EX PARTE REEXAMINATION COMMUNICATION TRANSMITTAL FORM

REEXAMINATION CONTROL NO. 90/012,884

PATENT NO. 0618,677 ET AL

Office Action in Ex Parte Reexamination	Control No. 90/012,884	Patent Under Reexamination 0618,677 S ET
	Examiner JEFFREY O. ASCH	Art Unit 2916

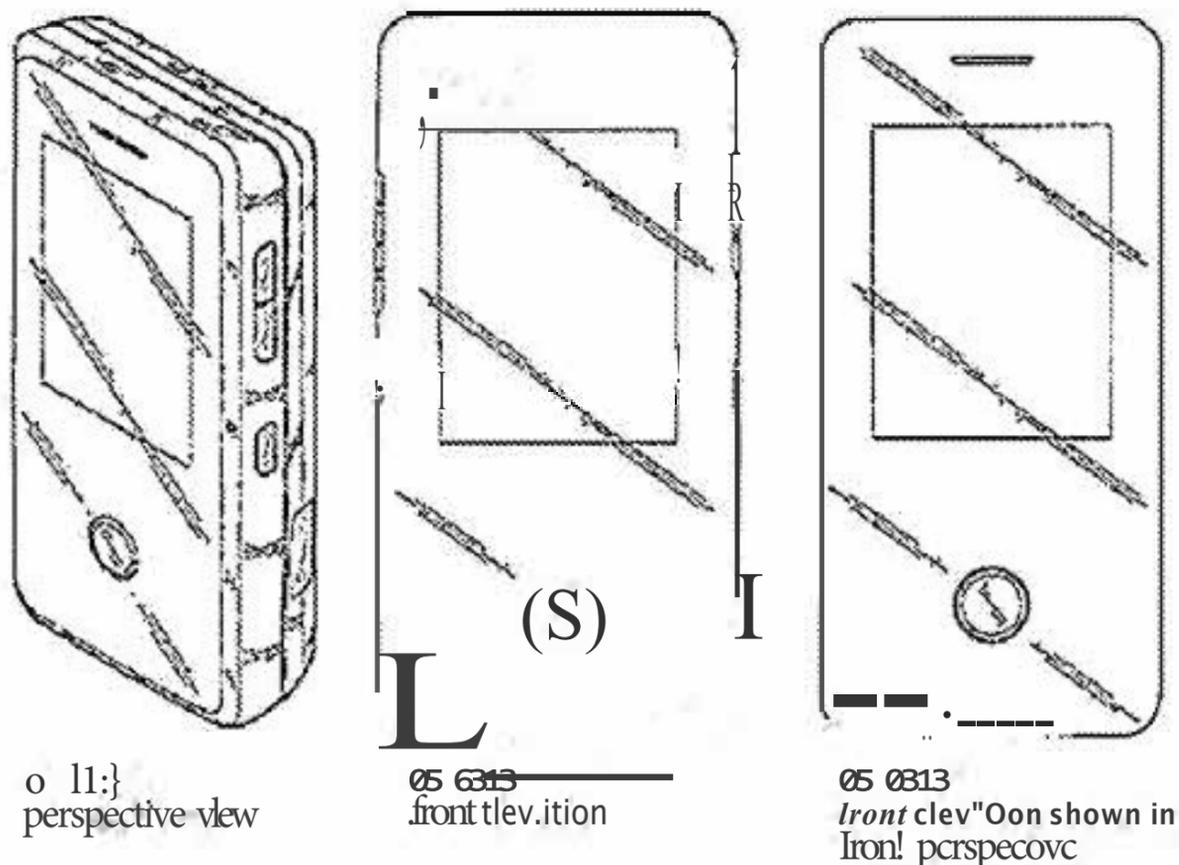
In 0618,677 the patented design has a solid-line outer perimeter that identifies the design's outer boundary. The examiner understands the broken lines in 0618,677 that show portions of the electronic device *beyond outerperimeter of the claimed design* to illustrate environmental subject matter that does not impact the claimed design. However, the examiner can only understand the broken line circle that exists within the outer perimeter of the claimed design to represent a boundary that acts as a limitation of the claim. *The only meaning the examiner can attribute to the broken line within the outer boundary of the claimed design is that it defines a circular shaped inner boundary for the claimed design.* The claimed design continues up to the edge of a circular feature.

The entire claimed surface in 0618,677 is shaded for the single color black. It has long been established that patentability may not rest on color alone. See *In re Iknayan et al.*, 124 USPQ 507, (1960). which states: "... and it follows that the claim distinguishes over the reference only on the basis of coloring. As was held in *In re Cohn*, 23 CCPA 766, 80 F.2d 65, 27 USPQ 412, 413, "It cannot be successfully argued that patentability of a design may rest on color alone." Moreover, the claim in 0618,677 was rejected for obviousness double patenting in view of 29/332683, now Patent 0618,678, and the only difference between the claims in the two applications is the specific color black in 0618,677. Therefore the selection of a single color applied to all claimed features is not a patentable distinction.

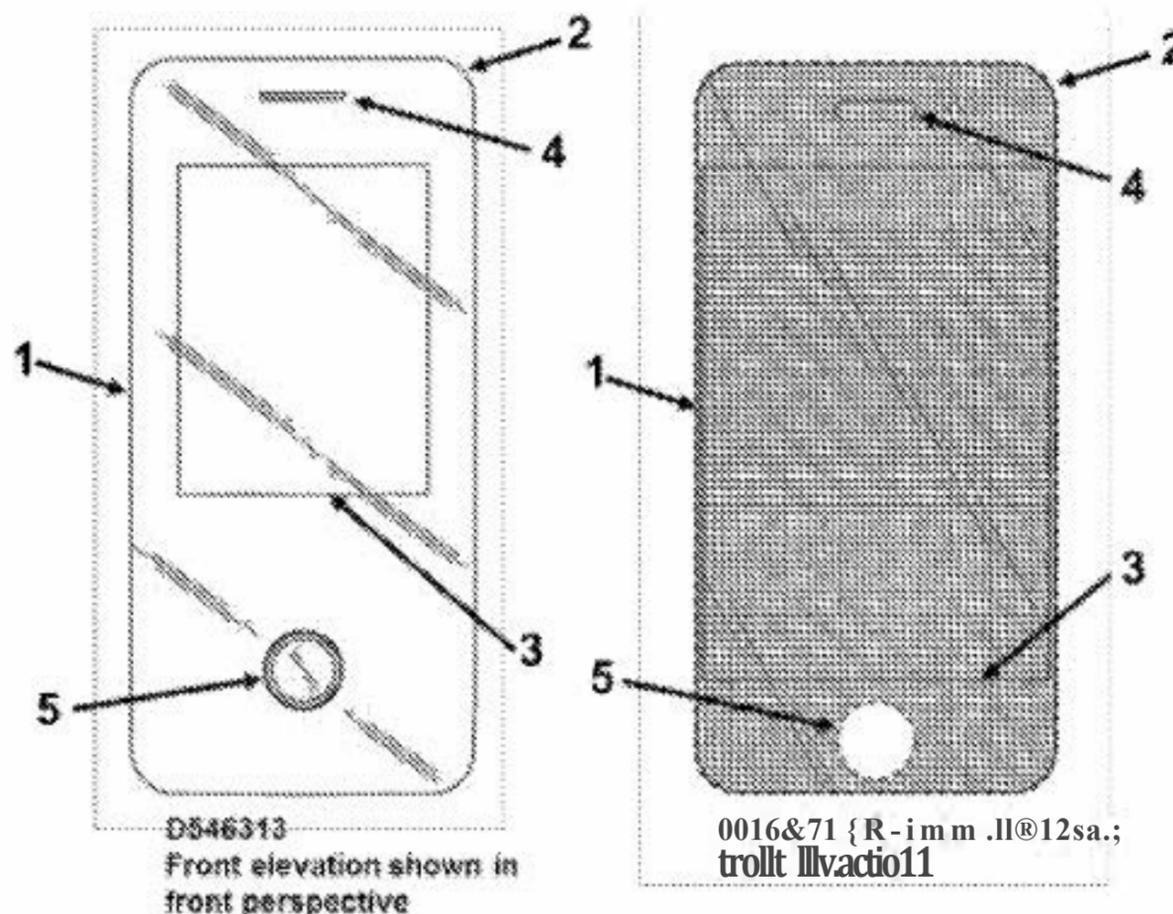
The examiner is relying on, as a basic reference, the planar front surface of 0546313 as shown in the front perspective view. The front perspective view shows a planar front surface with a continuous uninterrupted edge in the same plane as the front surface. The continuous uninterrupted front edge is not shown in the front elevation view of 0546,313. 0546,313 describes a planar front surface with a continuous edge because such a design was shown in the perspective view. For ease of comparison, as shown below right, the examiner has prepared a front elevation view showing the planar front surface as described in the perspective view.

The planar front surface of **0546,313** shares the same basic design characteristics with the claim in that the front perspective view shows 1- A flat panel with an outer rectangular shape having substantially the same aspect ratio. 2- Four evenly

rounded corners of substantially the same radius relative to the panel's dimensions, employed at the panel's outer corners. 3-The front surface is continuously flat and an inner rectangle, shown within the outer borders, with sharp corners (the display) can be seen through the outer surface. 4-Centered in the space above the display, slightly closer to the top edge of the outer frame, is an elongated slit-like opening (the speaker). 5- A circular shape of a specific size is centered in the space below the display, slightly closer to the bottom edge of the frame.

The difference between the planar front surface of 0546,313 and the claim of 0618,677 is that the inner rectangle (the display) in the 0618,677 design is larger with the margins at the sides being *very* narrow and the margin at the bottom being slightly larger than the one at the top. The secondary references, WO 2006/038499 to Ohki et al. or Japanese Patent JP01235888, both teach a larger display, with margins at the sides being *very* narrow and the margin at the bottom being slightly larger than the one at the top.

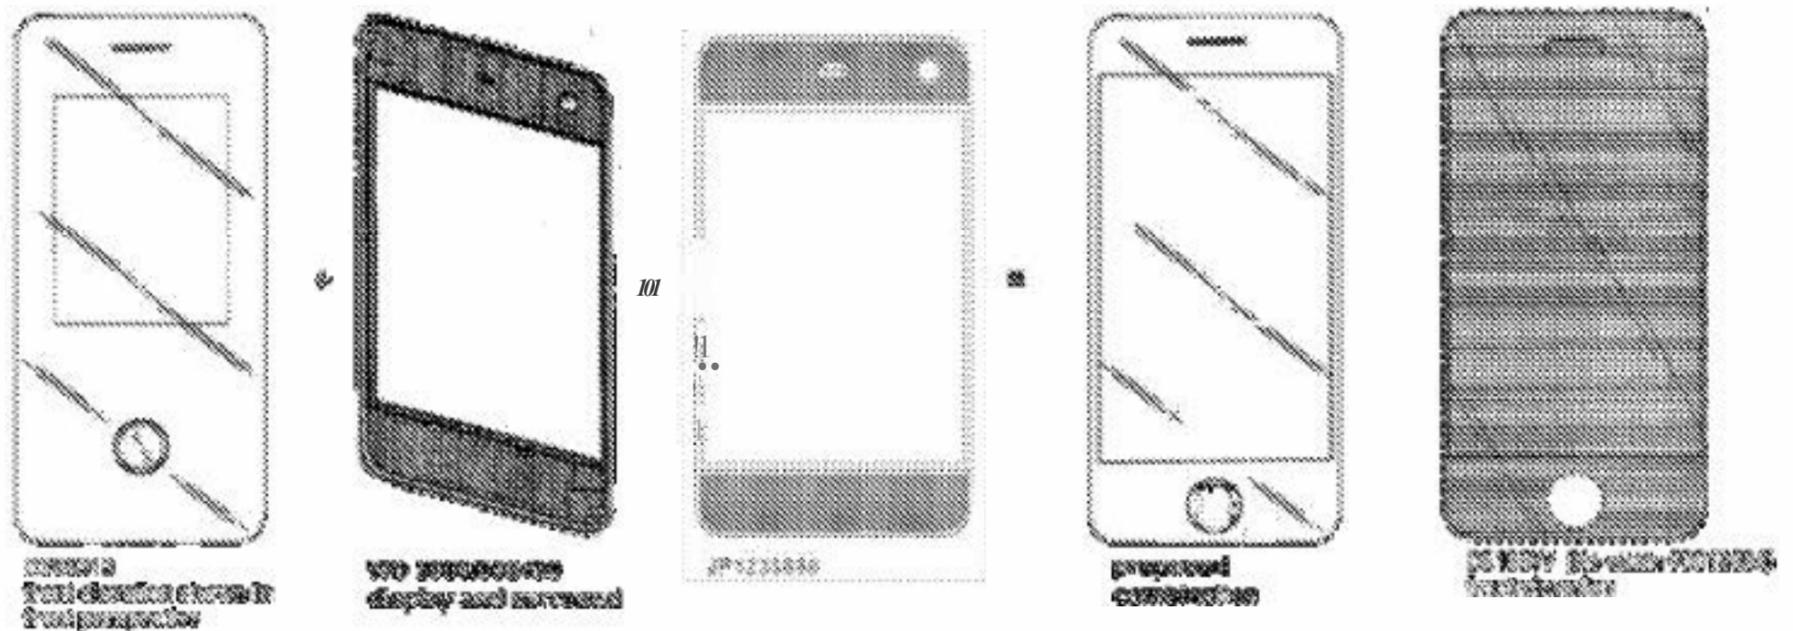
It would have been obvious to a designer of ordinary skill in the art at the time the invention was made to expand the size of the inner rectangle (the display) of 0546,313 so that the margins at the sides are *very* narrow and the margin at the bottom is slightly larger than the one at the top in the manner taught by WO 2006/038499 to Ohki et al. or Japanese Patent JP01235888. In such a modification it would be obvious for the circular feature at the bottom, to maintain its position centered within the space below the display, slightly closer to the bottom edge of the frame.

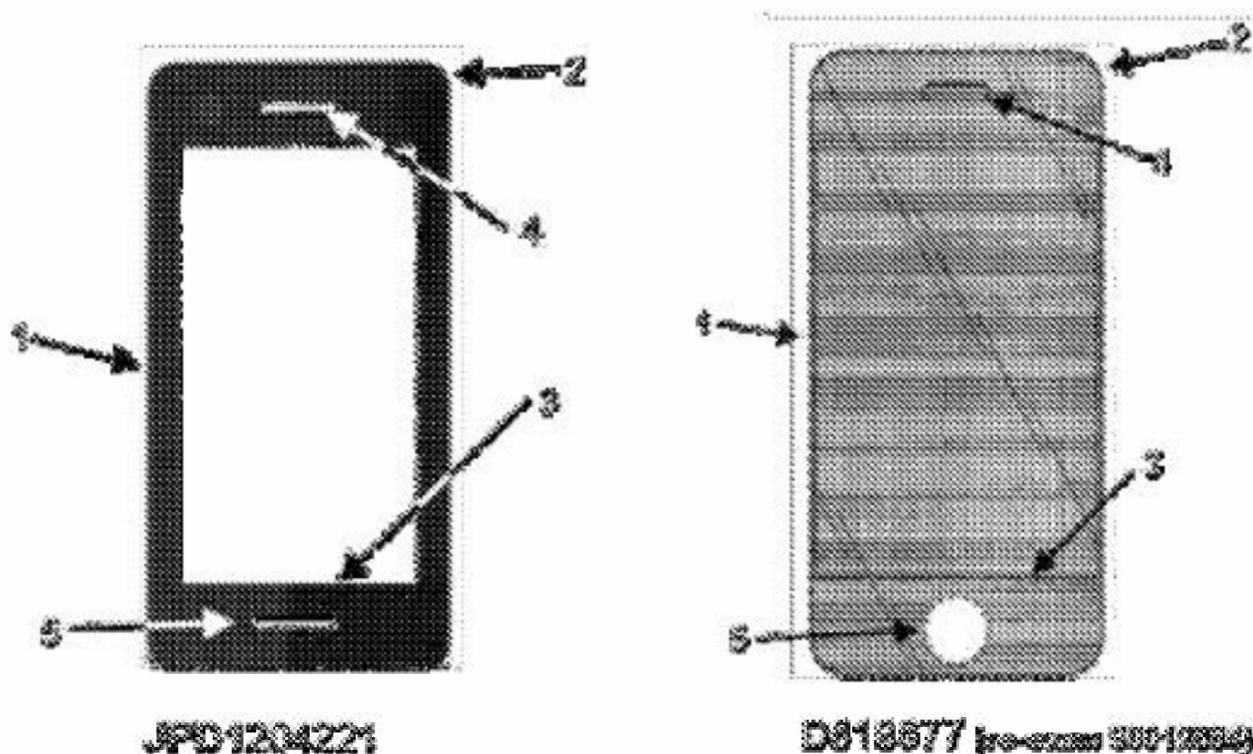
The examiner is relying on, as a basic reference, the planar front surface of JPD1204221. Although difficult to see due to the solid black color surrounding the display, the planar front surface includes an elongated feature at the top and bottom of the screen. For ease of comparison the examiner has prepared a front elevation view of JPD1204221 wherein the display, and apertures above and below the display, have all been shown in white.

JPD1204221 at the front surface shares the same basic design characteristics with the claim including 1- A flat panel with an outer rectangular shape having substantially the same aspect ratio. 2- Four evenly rounded corners of the substantially the same radius relative to the panel's dimensions, employed at the panel's outer corners. 3-The front surface is continuously flat and an inner rectangle, shown within the outer borders, with sharp corners (the display) can be seen through the outer surface. 4-Centered in the space above the display is an elongated slit-like opening. 5, A feature is shown centered in the space below the display.

The differences between the planar front surface of JPD1204221 and the claim of D618,677 is that the inner rectangle (the display) in the primary reference is narrower and the feature at the bottom is circular rather than elongated. Either of the secondary references. JP1235888 or US Patent D577,703 teaches a wider display within an outer frame, expanded to near the sides. 0546,313 or US PApub 2004/0223004 teaches a circular function button below the display.

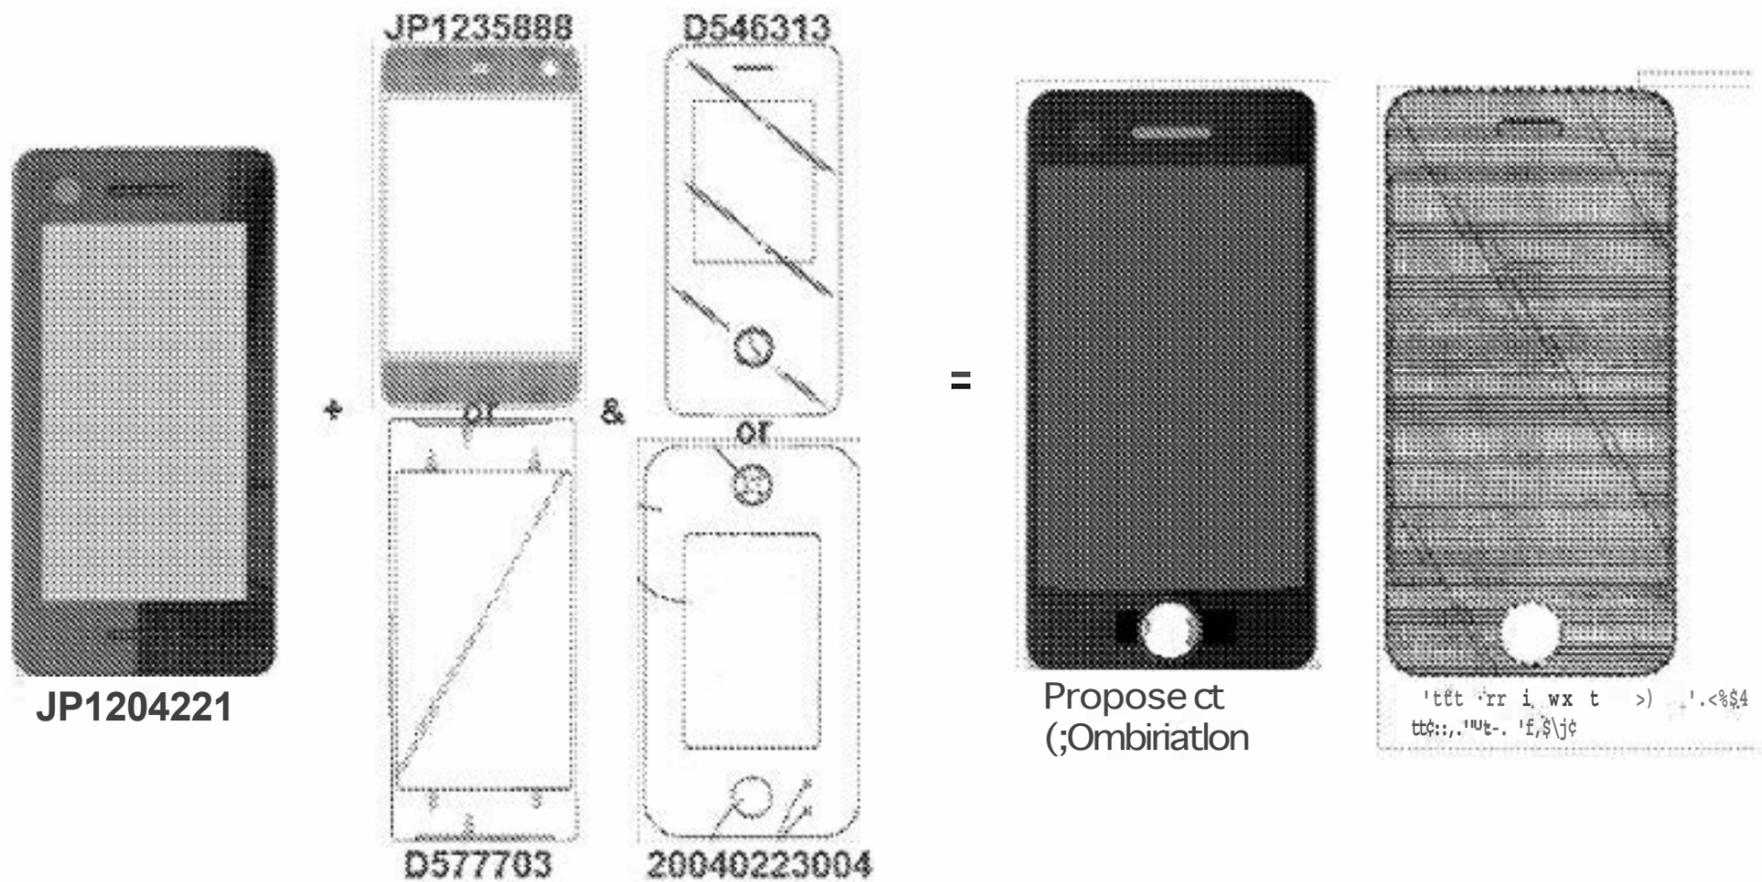
It would have been obvious to a designer of ordinary skill in the art at the time the invention was made to expand the width of the inner rectangle {the display} of JPD1204221 in the manner taught by JP1235888 or D577,703 and to substitute the bottom feature with the circular function button of 0546,313 or 2004/0223004.

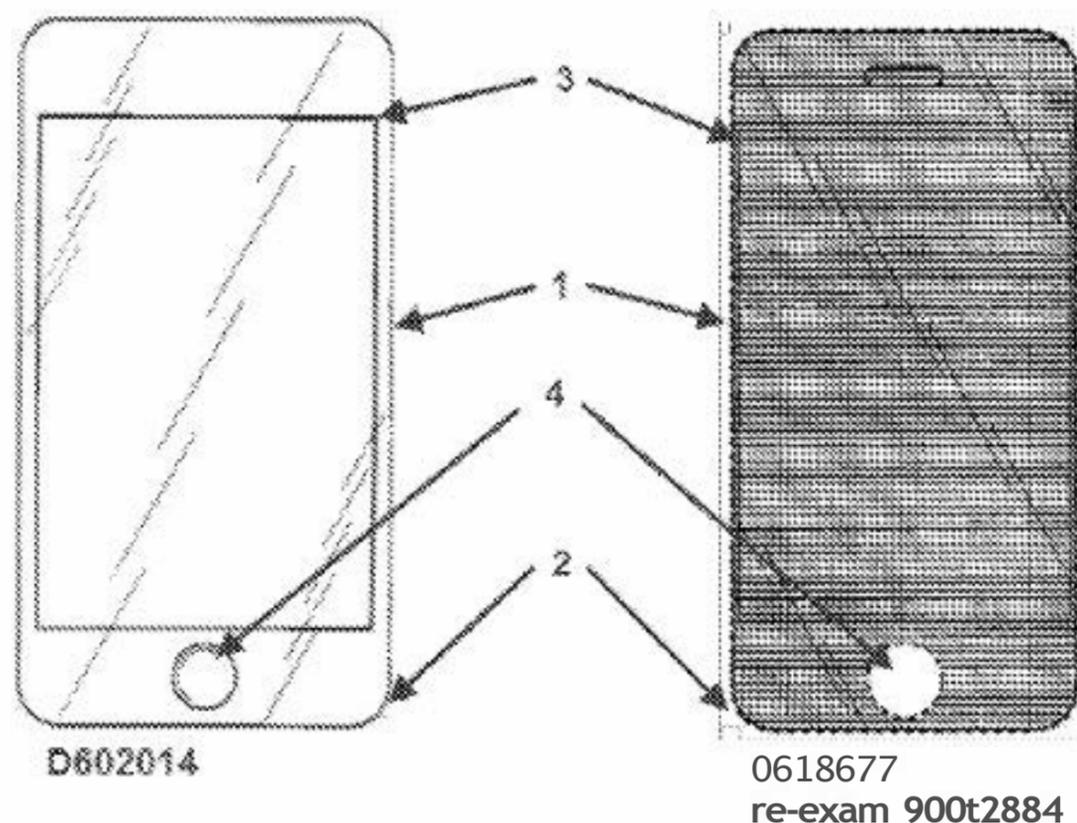
The planar front surface of **0602,014** shares the same basic design characteristics with the claim including 1- A flat panel with an outer rectangular shape having substantially the same aspect ratio. 2- Four evenly rounded corners of substantially the same radius relative to the panel's dimensions, employed at the panel's outer corners. 3-The front surface is continuously flat and an inner rectangle, shown within the outer borders, with sharp corners (the display) the same relative proportions can be seen through the outer surface. 4- A circular shape of a specific size centered in the space below the display.

The only difference between the planar front surface of 0602,014 and the claim of 0618,677 is that 0602,014 does not have a speaker opening at the top, centered above the screen. The secondary references, 0543, 183 to Cho et al. 0562,285 to Lim, both teach a capsule shaped speaker opening catered above the display.

It would have been obvious to a designer of ordinary skill in the art at the time the invention was made to add a speaker opening above the display of 0602,014 in the manner taught by 0543, 183 to Cho et al. or 0562,285 to Lim.
